BARANGAROO SOUTH

Stage 1B Public Domain Modification S4.55

Project
BARANGAROO STAGE 1B
PUBLIC DOMAIN
Modification S4.55

Drawing Title
BARANGAROO AVE SOUTH
DETAIL PLAN - NO TREES

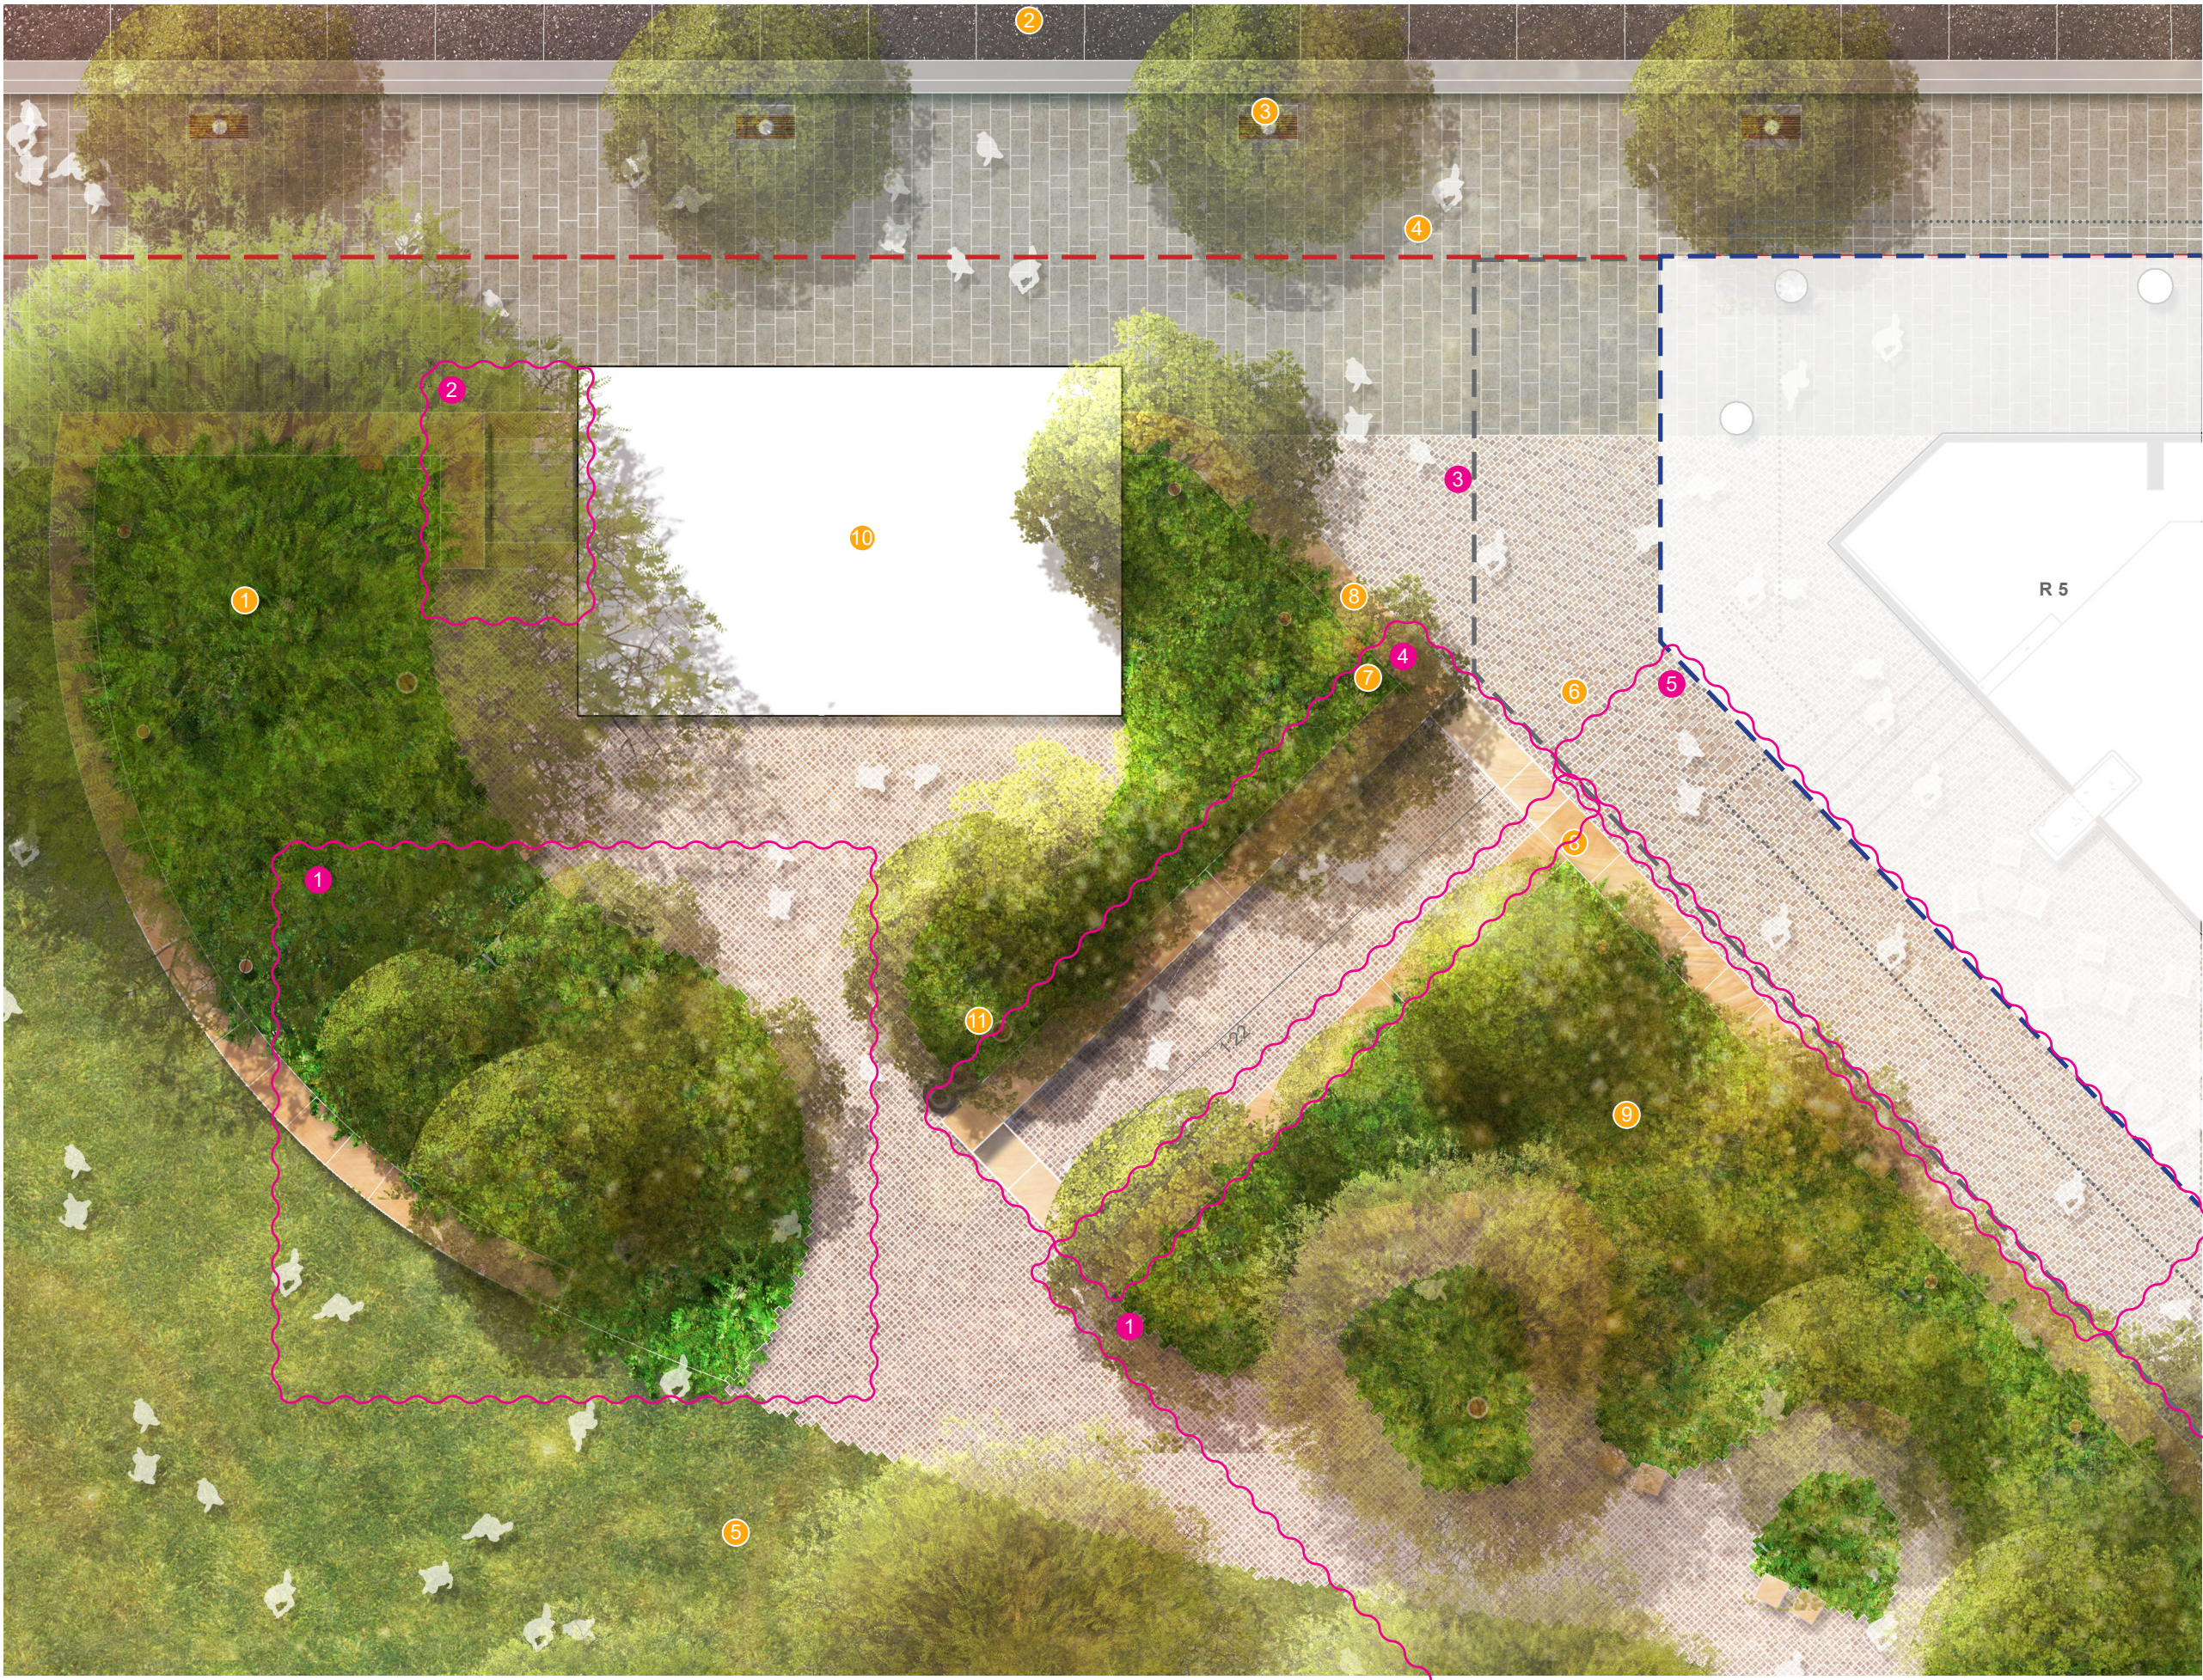
- Proposed Modifications**
- Amendment cloud
 - 1 Additional smart pole
 - 2 Not in use
 - 3 Relocated Fig tree to North raised planter

Drawing Title
**HICKSON PARK EAST ENTRY
DETAIL PLAN - TREES**
Drawn
SS

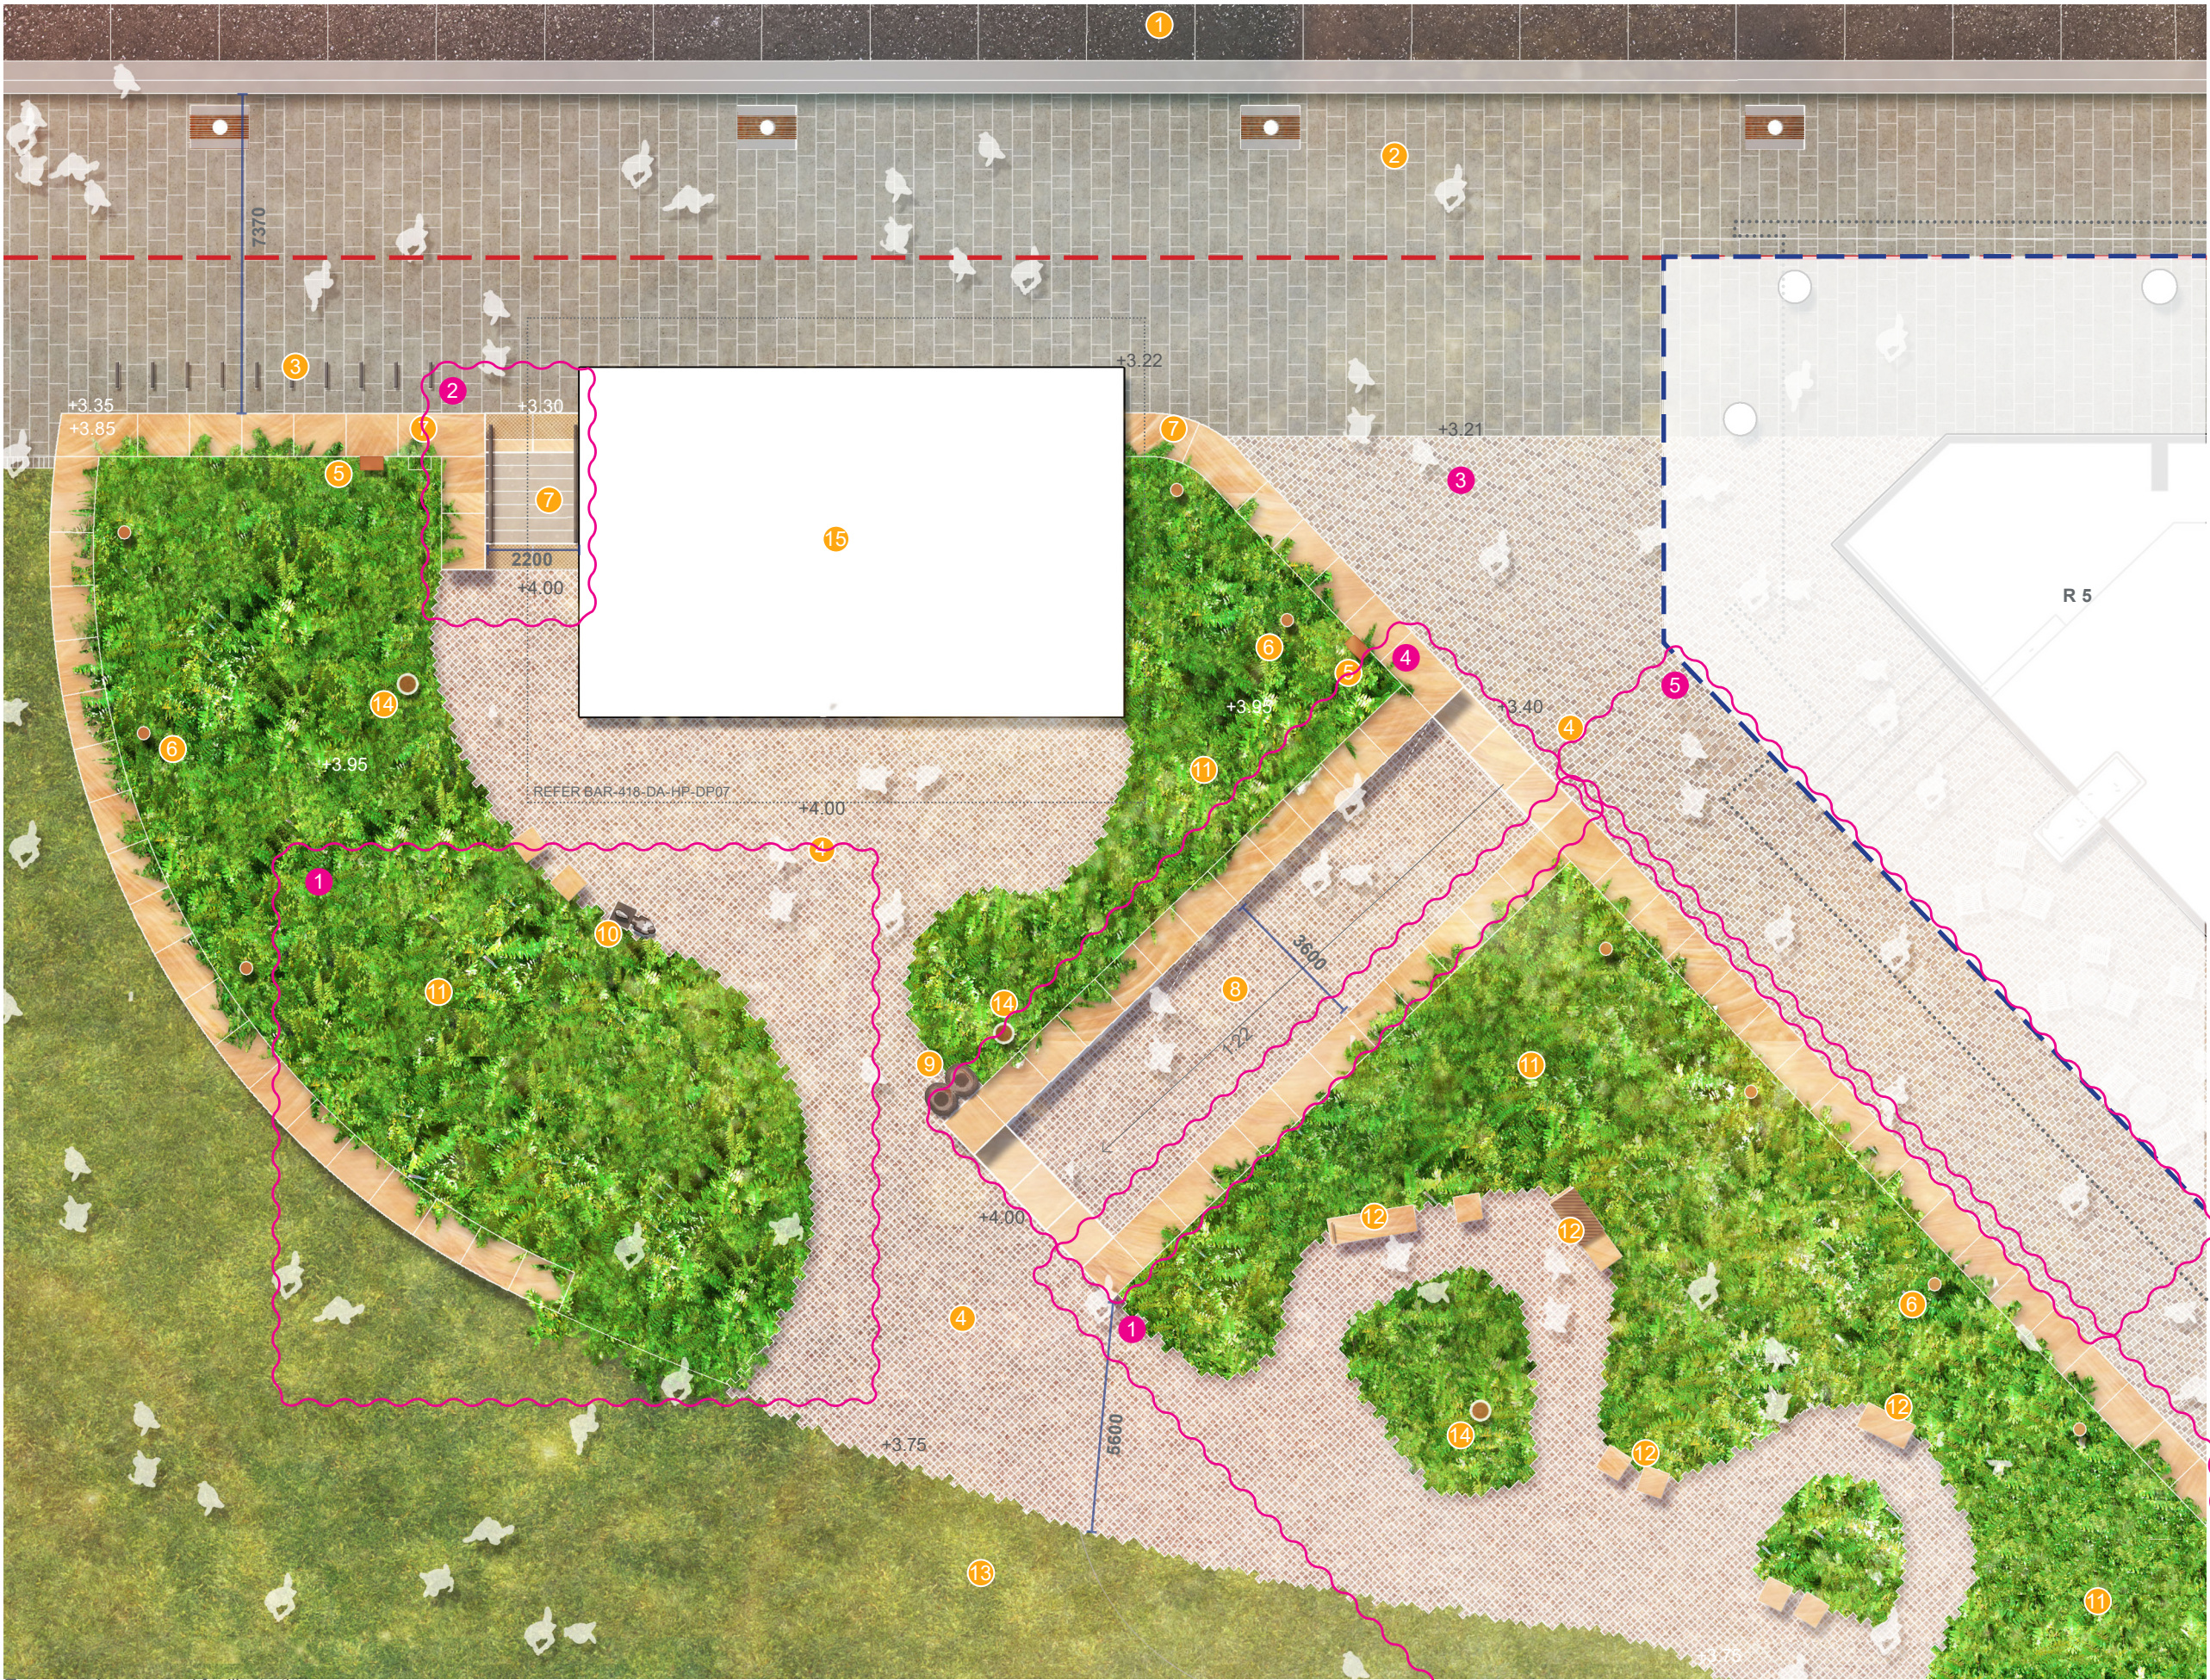
- Proposed Modifications**
- Amendment cloud
 - 1 Increase planting area within the park, change of geometry
 - 2 Stone stairs changed to concrete
 - 3 Remove porphyry paving to City of Sydney transition as per consent requirement B23
 - 4 Shallower ramp, remove handrail, landing, and tactiles due to proposed Hickson Road levels
 - 5 Remove ramp and sandstone wall due to proposed Hickson Road levels

Drawing Title
**HICKSON PARK EAST ENTRY
DETAIL PLAN - NO TREES**

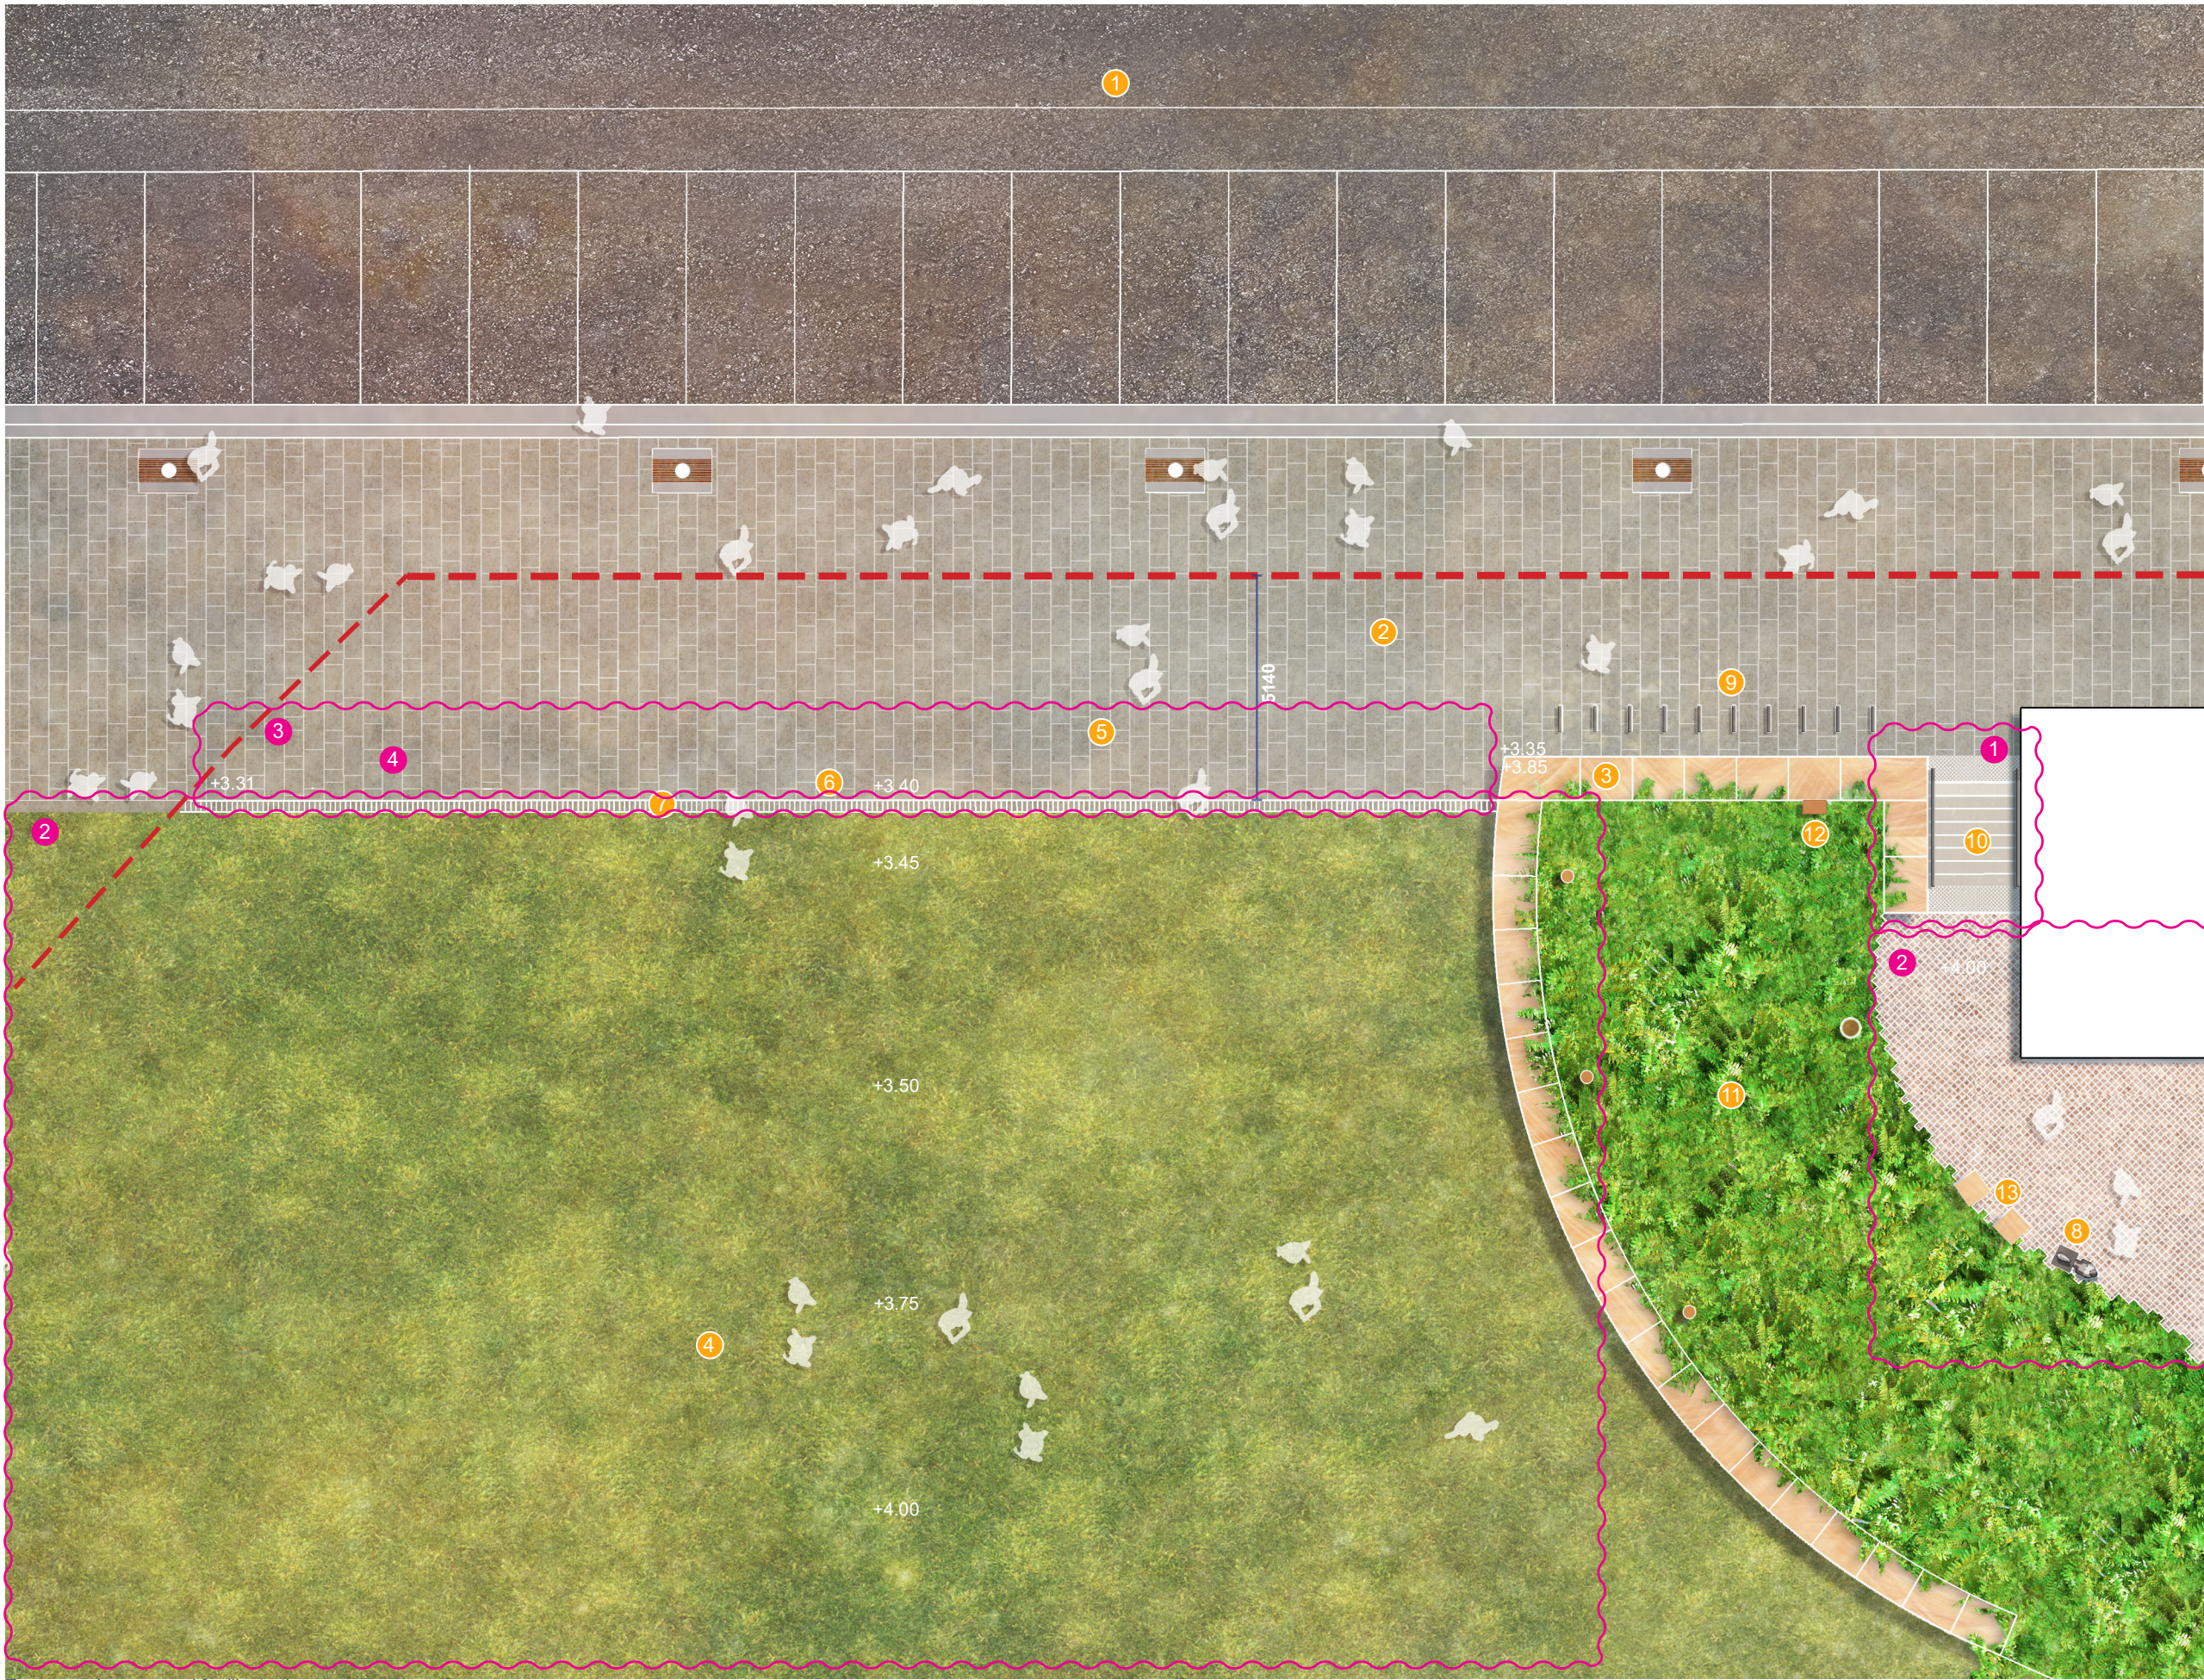
- Proposed Modifications**
- Amendment cloud
 - 1 Increase planting area within the park, change of geometry
 - 2 Stone stairs changed to concrete
 - 3 Remove porphyry paving to City of Sydney transition as per consent requirement B23
 - 4 Shallower ramp, remove handrail, landing, and tactile tiles due to proposed Hickson Road levels
 - 5 Remove ramp and sandstone wall due to proposed Hickson Road levels
